Index 700-101

Typical Sections for Placement of Single and Multi-Column Signs

COMMENTS AND RESPONSES

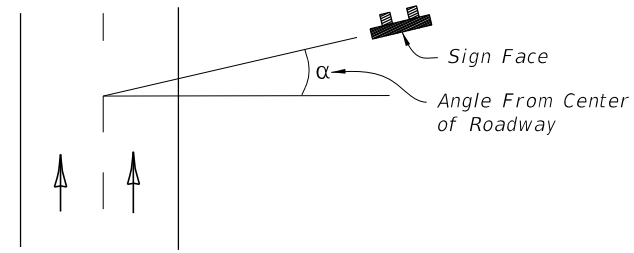
COMMENT: Sidewalk Detail: Since a single-column cantilever ground-mounted sign is shown, the maximum vertical clearance should be 9'-0"', as indicated in the Typical Section on Ind. 700-011, sheet 1 of 2.

RESPONSE: Thank you for the comment. The details for the shared use path and the urban side path will be updated to 8' minimum.

LAST REVISION 11/01/25	REVISION	DESCRIPTION:	 FY 2026-27 STANDARD PLANS	TYPICAL SECTIONS FOR PLACEMENT OF SINGLE AND MULTI-COLUMN SIGNS	INDEX 700-101	SHEET 1 of 2
---------------------------	----------	--------------	---	--	------------------	-----------------

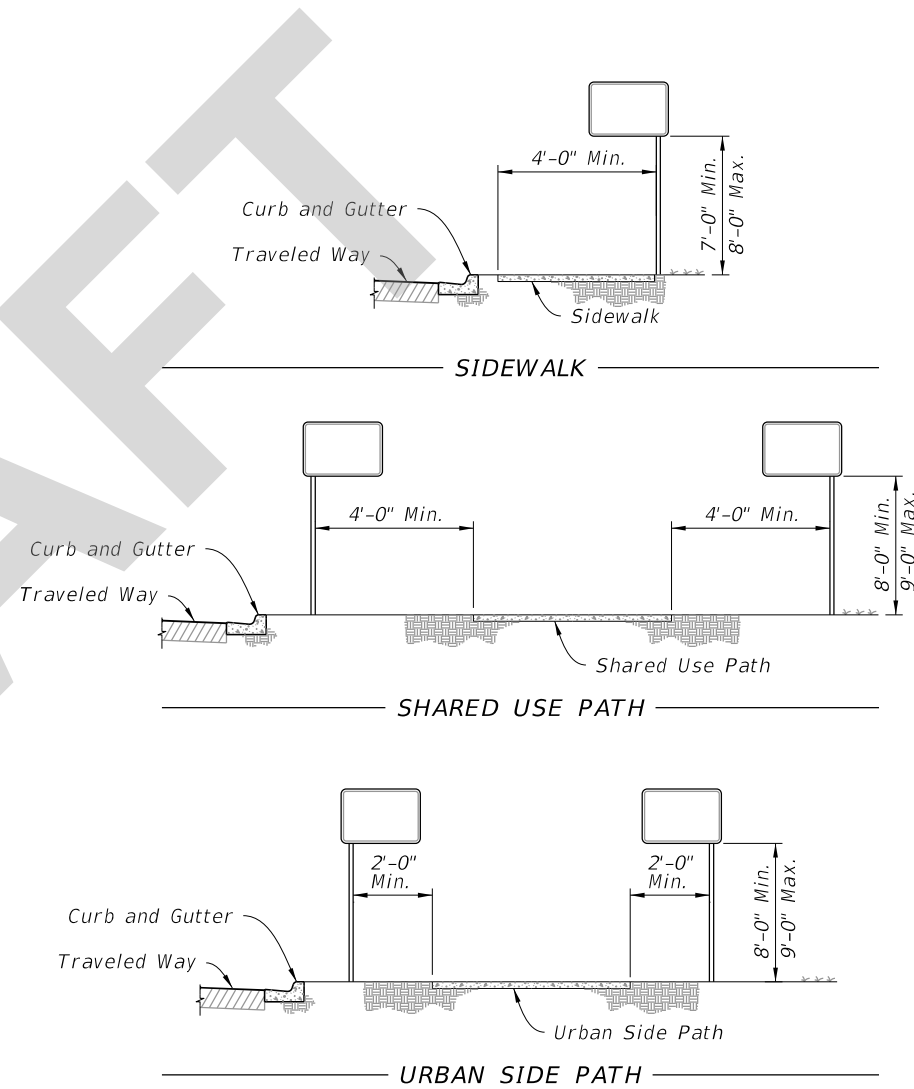
Note 7 does not provide enough information for placing signs along a shared use path or urban side path. Additional language is needed inform proper placement of sign columns along shared use and urban side paths.

COMMENT: Sidewalk Detail: Since a single-column cantilever ground-mounted sign is shown, the maximum vertical clearance should be 9'-0", as indicated in the Typical Section on Ind. 700-011, sheet 1 of 2.

COMMENT: Shared Use Path Detail: Since the SUP is utilized by bicyclists and micro-mobility users, who may off-track, it is recommended to provide a standard vertical clearance of 10' (8' minimum) for sign panels extending over both the SUP and its horizontal clear area. The same consideration should also be applied to Urban Side Paths. Note: if these recommendations are implemented, please update FDM Section 224.8 accordingly.

RESPONSE: Thank you for catching the inconsistency. To stay consistent with the other cases in Index 700-101, we will leave the max height at 8' and revise the max height in Index 700-011 to 8'.

RESPONSE: Thank you for the comment. Currently our requirements state that the minimum clearance should be 8'. The detail will be updated to show this 8' clearance.

6. Do not install sign supports in the bottom of ditches.
7. CASE X sign placement is for Interstate Exit Ramps only. Use CASE I through Case VIII as appropriate for all other Wrong Way signs.
8. Sign Supports:
 - A. Install sign supports, so they do not reduce the accessible width of sidewalk to less than 4' min. clear width.
 - B. Install sign supports along shared use paths, so a 4-foot clear area is adjacent to both sides of the shared use path.
 - C. Install sign supports along urban side paths so there is a 2-foot buffer along both sides of the path.
